Product Change Notice: Part Number ERZ-U14JP511B Type J ZNR Transient Surge Absorber

PCN.PG33.07.01.2019

Dimensional specification change for part number ERZ-U14JP511B as follows:

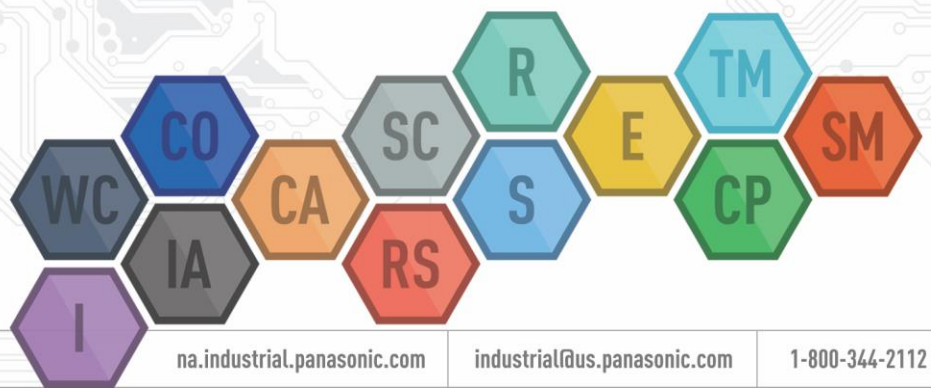
Prior:

Dimension A: 268mm

Dimension B: 288mm

Now:

Dimension A: 260mm

Dimension B: 280mm
